HISTORIC PRESERVATION COMMISSION

Final Staff Report

CASE NUMBER: HPC12-42
CITATION ISSUED: No
ADDRESS: 116- 118 E PATRICK ST
APPLICANT NAME: Norman Morin, Jr.
PREPARED BY: Lisa Mroszczyk Murphy
DATE: March 2, 2012

116-118 EAST PATRICK STREET ALTERATIONS & ADDITIONS

UNIT SECTIONS

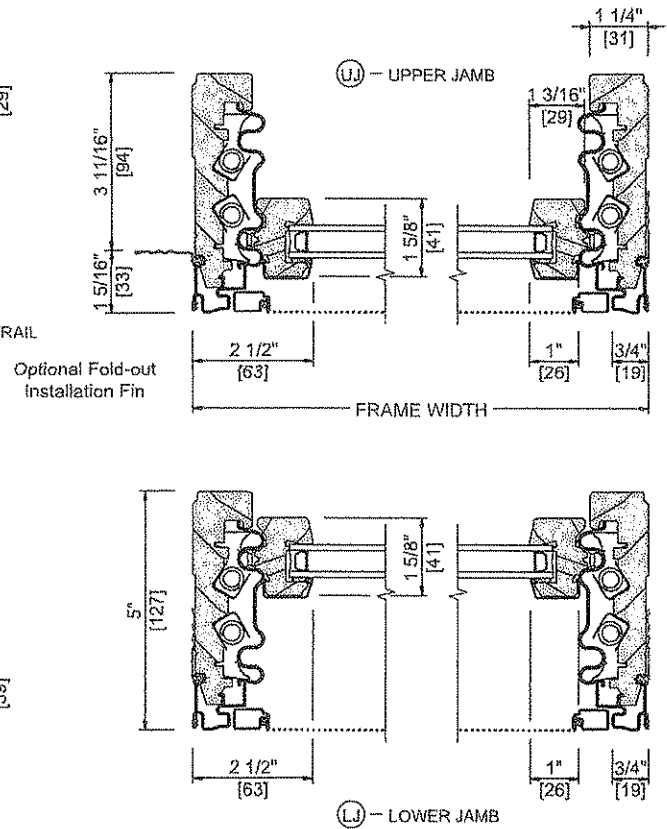
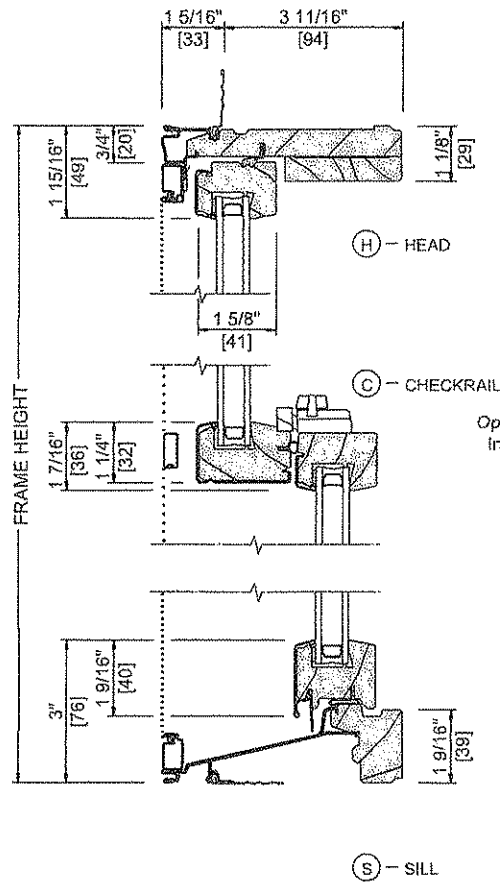
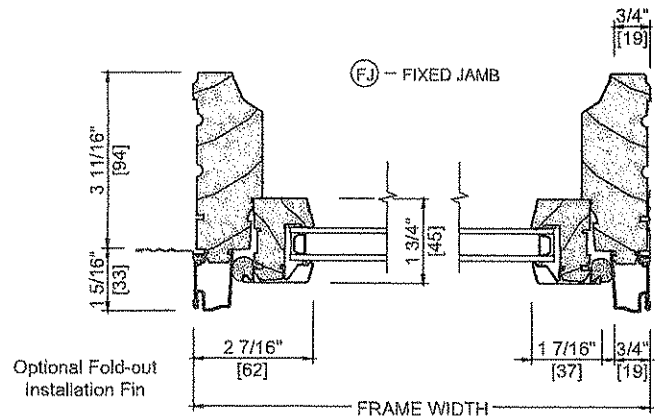
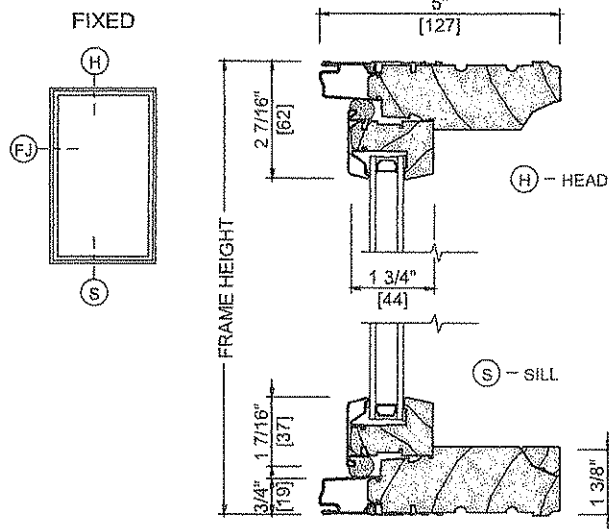
The "simulated divided light" windows proposed feature permanently affixed muntins on the interior and exterior of the window but they do not feature a spacer bar between the panes of glass that would provide the shadow that would typically occur in a true divided light window. The same manufacturer does offer "integral light technology" grilles which have the permanently affixed muntins and a spacer bar. This option, or a comparable option from another manufacturer, would be more appropriate and compatible with historic windows. The aluminum cladding does hold a better profile and is more durable than other cladding materials and provides differentiation between old and new.

- The windows feature simulated divided lights with permanently affixed muntins and a spacer bar.
- All other materials not identified at this time, such as light fixtures, are to be submitted for staff approval prior to applying for permits.

DEMOLITION
PLANS
D1.1
2 OF 6 SHEETS
DATE: 2/29/12

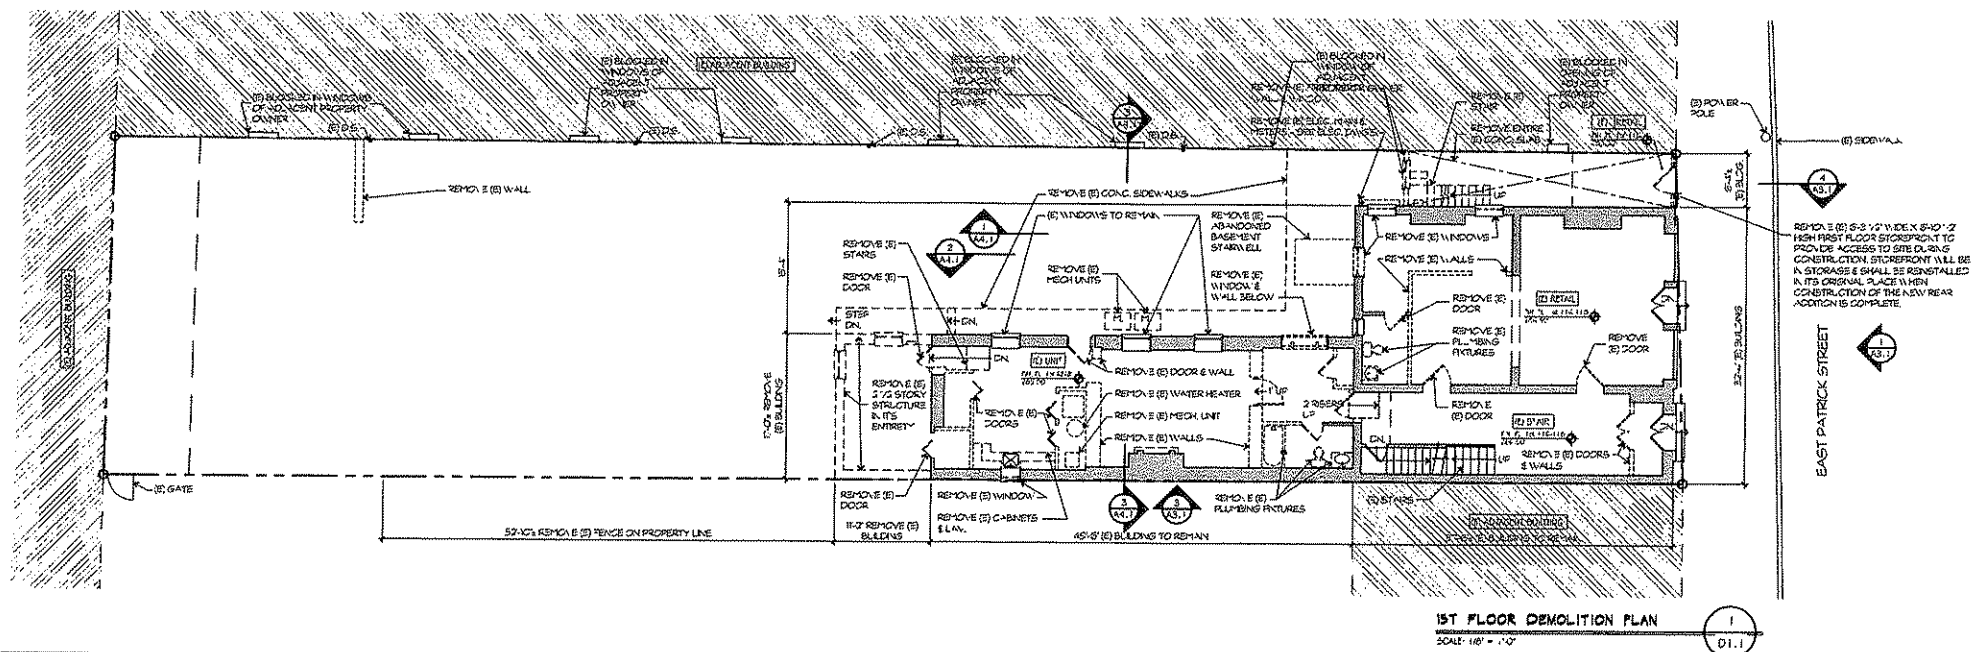
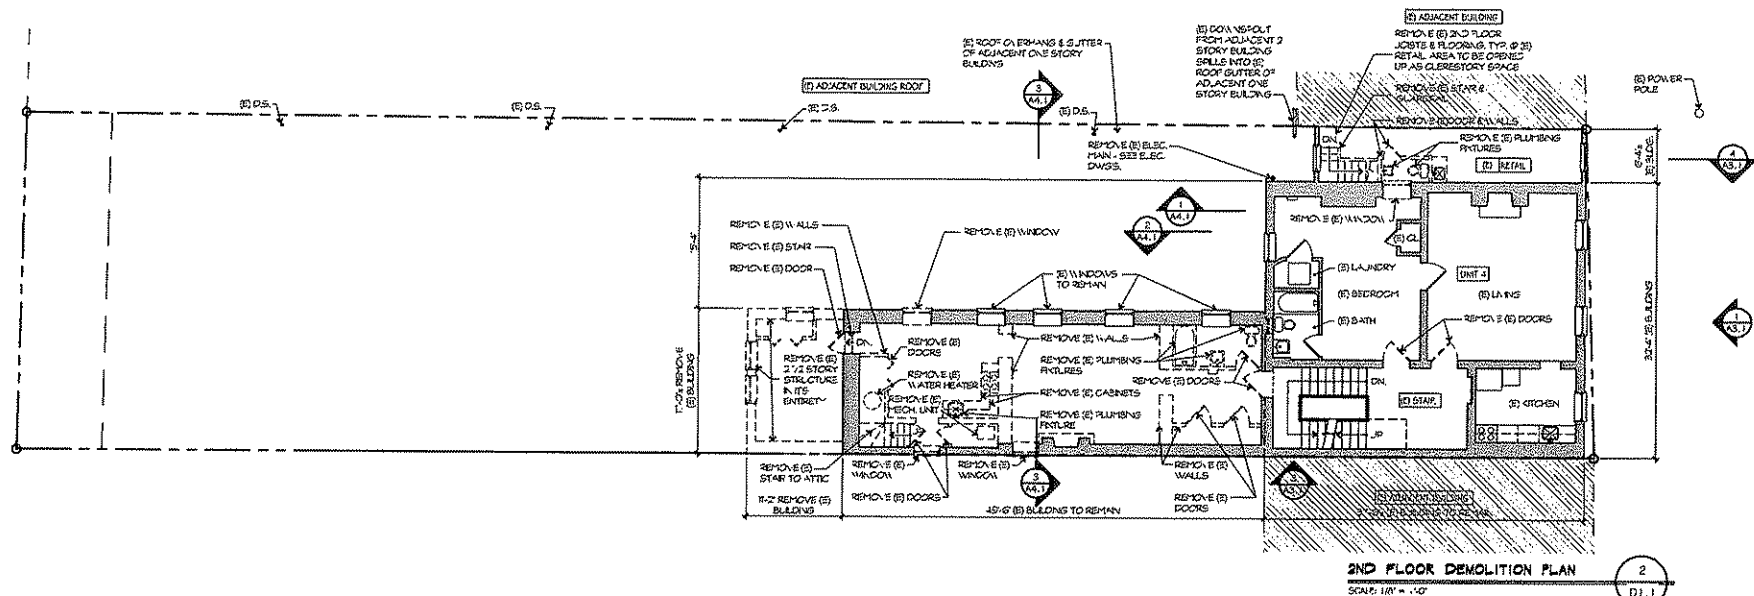
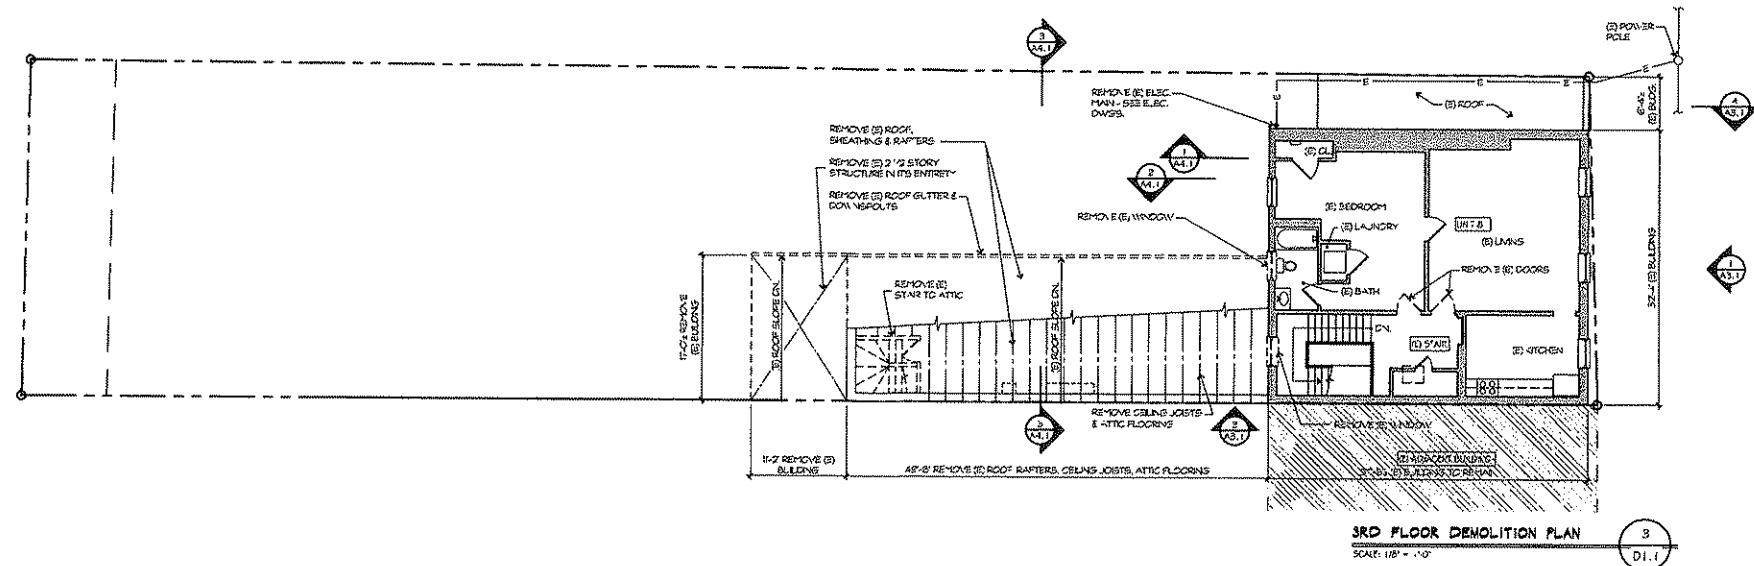
According to Sanborn maps, the narrow historic frame building dates from 1911-1922 and was at that time used as storage for the main commercial building at 116-118. The rear of this building does not exhibit any unique characteristics or contribute to the architectural or historical value of the resource. Therefore, staff finds that it is appropriate to remove the first floor to accommodate the construction of the addition. Regarding the storefront of this frame section, staff can support its temporary removal provided the applicant can ensure that it is not damaged or altered during

the process and is reinstalled as it currently exists. The remainder of the structure should also be protected and stabilized as necessary to prevent any damage.
